FINAL GENERIC ENVIRONMENTAL IMPACT STATEMENT

Proposed Heartland Town Square

Volume 1 of 3
Text, Tables and Figures

February 2014

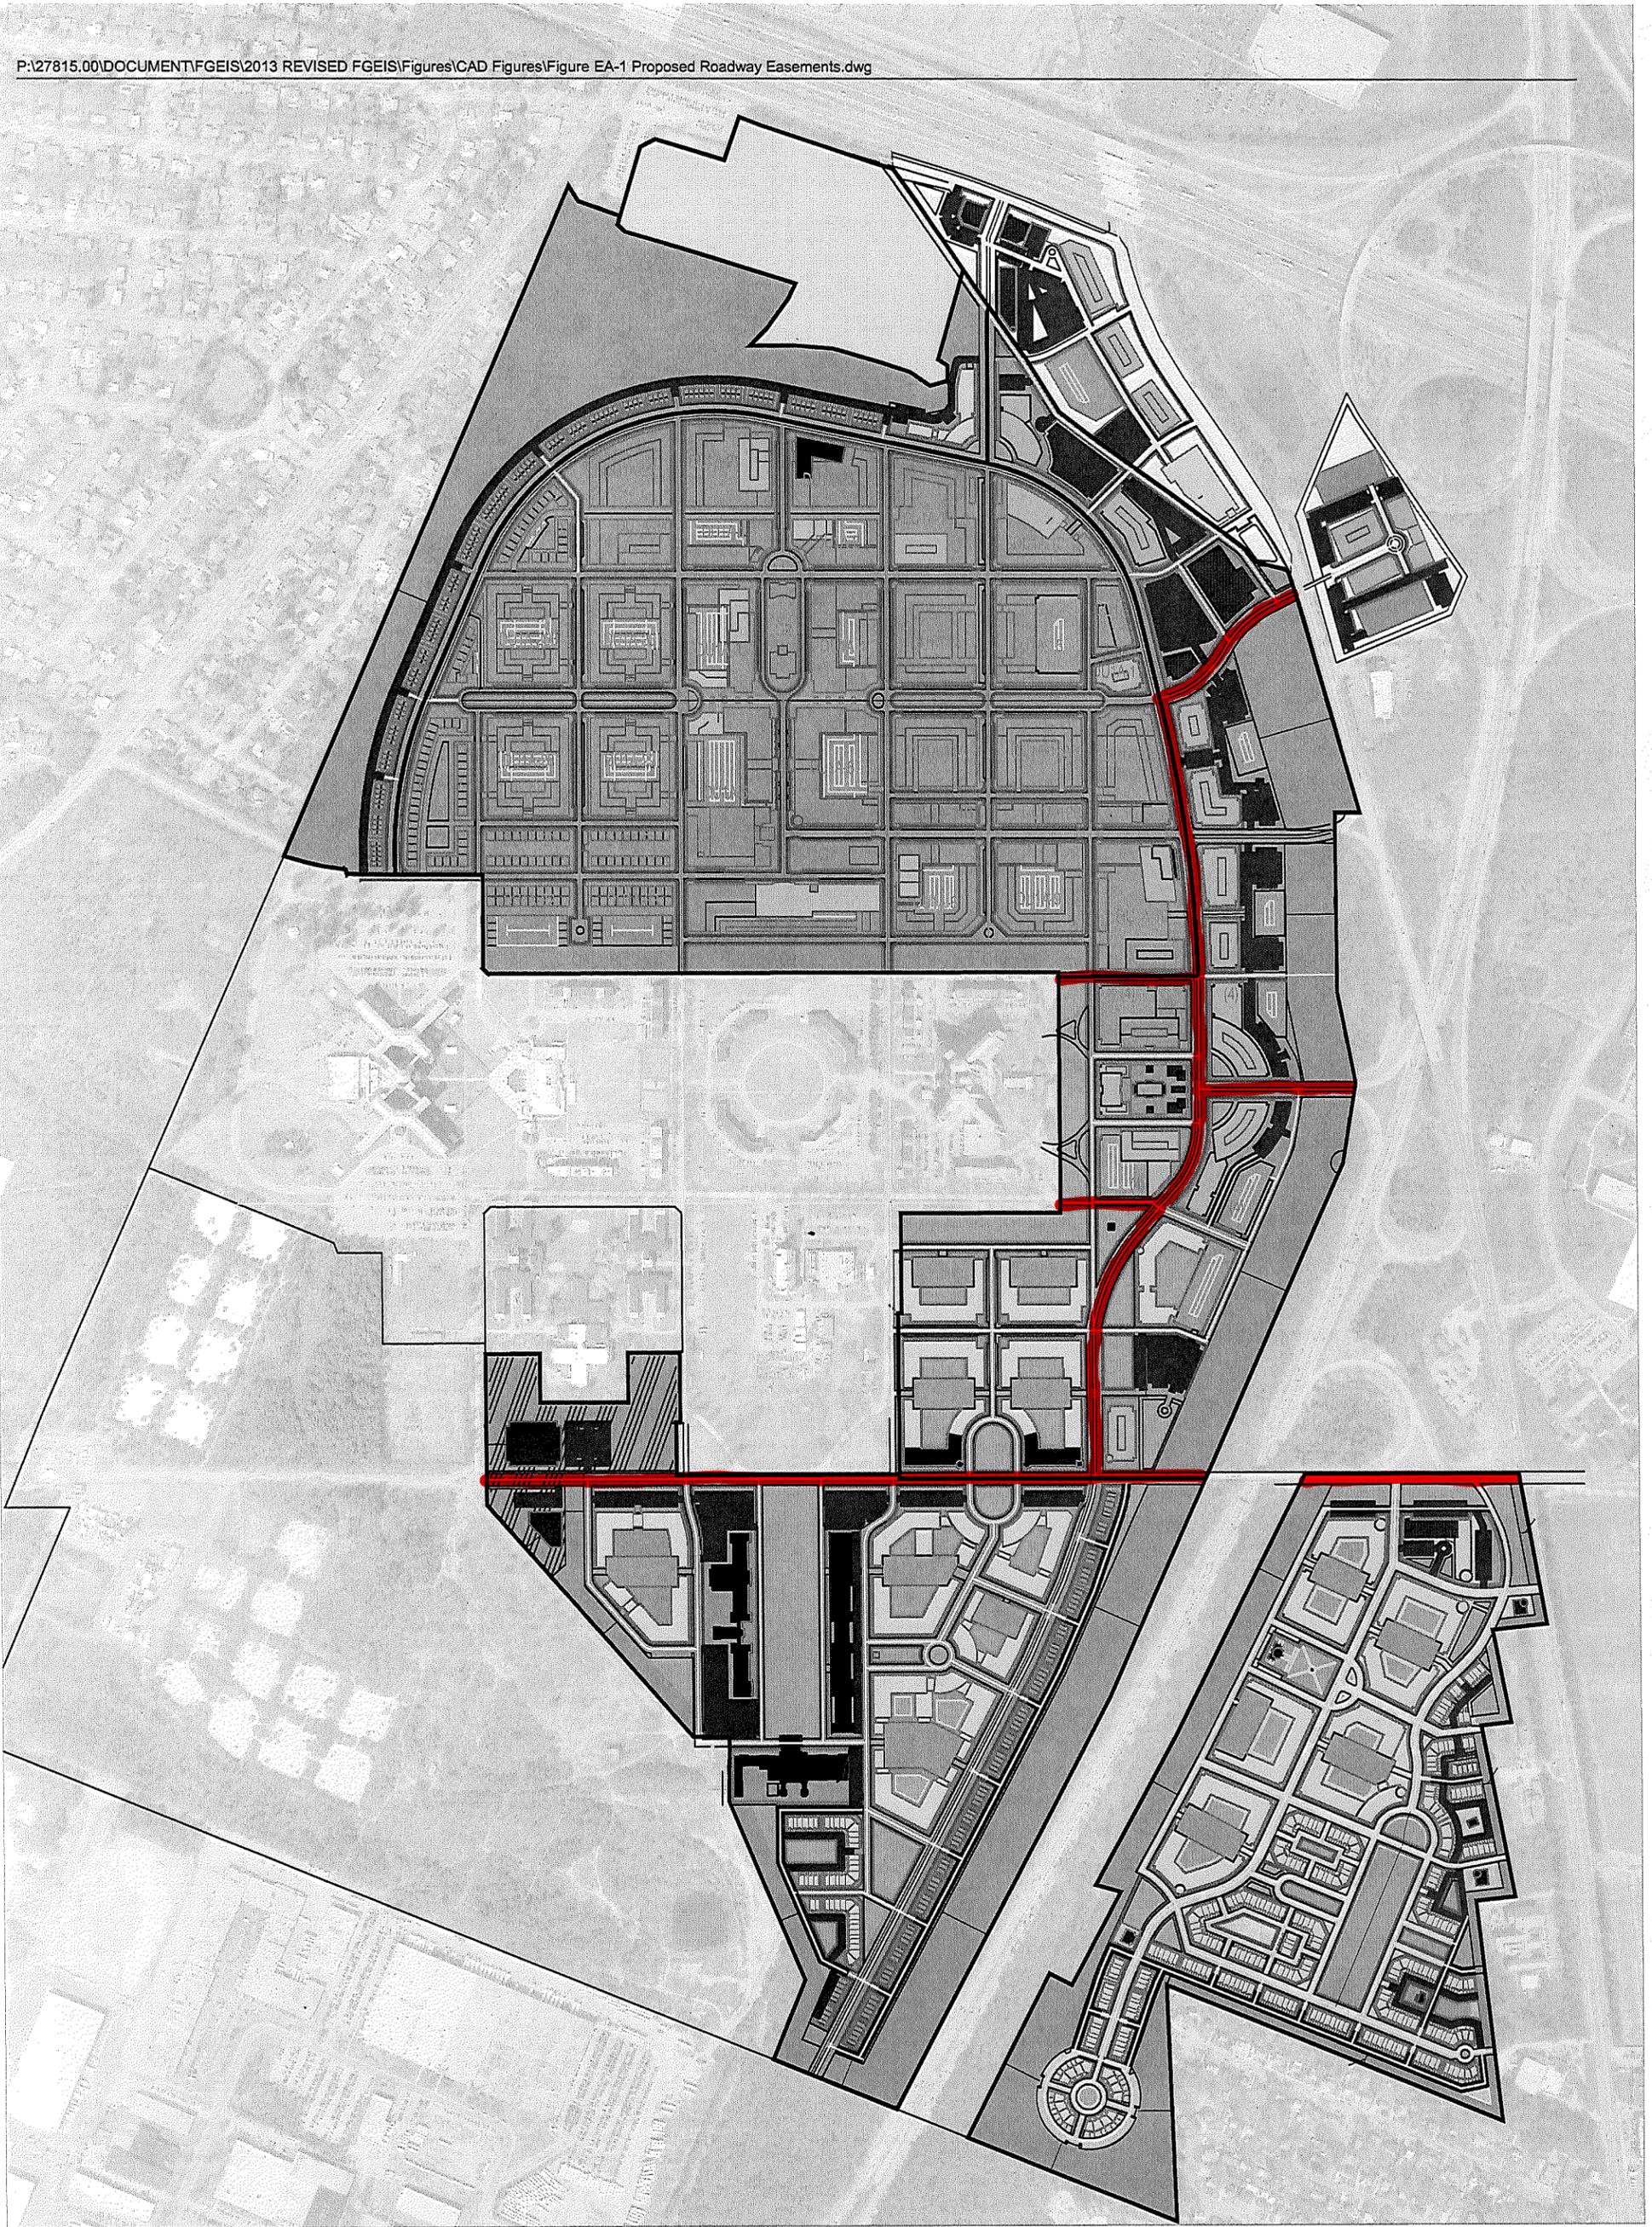
A primary concern that is the document does not address the easements which we retained when the property was transferred. When the 452 acres were transferred first to the NYS Urban Development Corporation, then to the Town of Islip Industrial Development Agency (IDA) and subsequently to the developer, the State retained easements for infrastructure. For your convenience, we are attaching a map which we prepared of those easements. The State also retained guaranteed access to the Sagtikos and Crooked Hill Road over existing roadways. The proposed development plan does not appear to consider the existence of these easements and their effect on the proposed development. (C13-1)

As no detailed engineering plans have yet been developed for the project, it is not possible to determine at this time exactly how each utility easement or easement segment may need to be modified. The following table tentatively addresses each of the utility easements identified on the "Map Showing Permanent Easements to be retained at Pilgrim Psychiatric Center," prepared by Carman-Dunne, PC, dated February 14, 2000. The existing utility easements are shown on Figure EA-2. The anticipated modifications listed in the table are based on the revised Conceptual Master Plan (see Appendix RP-1 of the FGEIS); as detailed site engineering plans are developed and input from the utility providers becomes available, the specifics of any modifications of these easements will be assessed. Any utility easements requiring modification will be coordinated with OMH pursuant to the terms of the Purchase and Sale Agreement. The proposed roadway easements are discussed in Response EA-2 and shown on Figure EA-1.

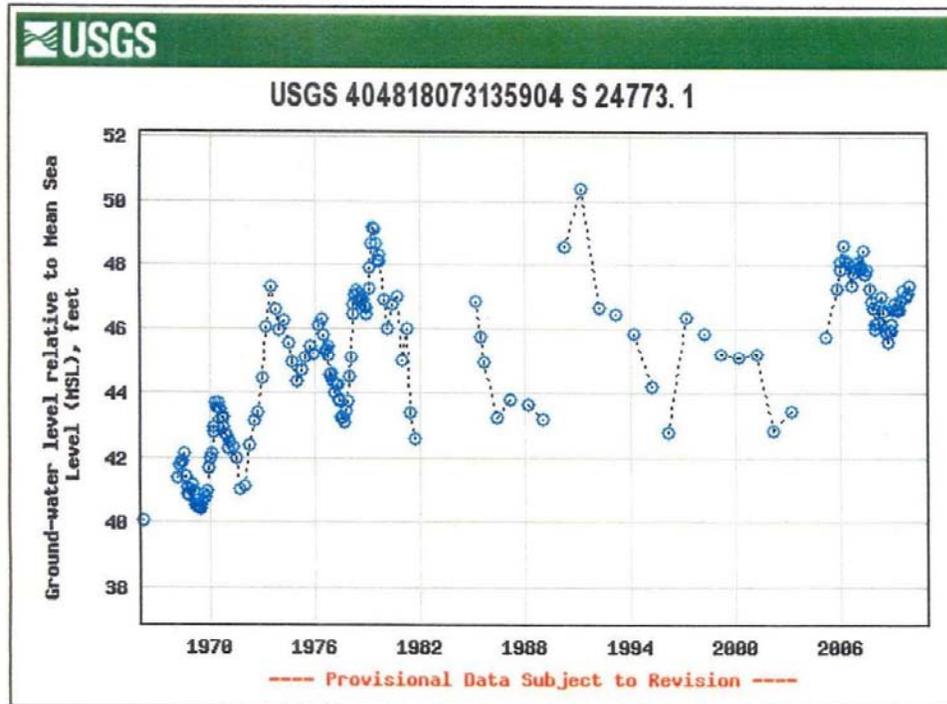
This is especially worrisome when one considers that this project is being built close to if not on one of the last aquifers in Suffolk County. Where are we supposed to get our water from if our aquifers are covered by concrete? (C22-5)

All of Long Island is located above groundwater aquifers. These aquifers stretch across Long Island from Queens County to Suffolk County. Groundwater recharge within the SGPA is being protected through connection of the proposed development to the Southwest Sewer District and through enhanced stormwater pollution prevention measures. Furthermore, no industrial uses are proposed in this project, reducing the potential for contamination.
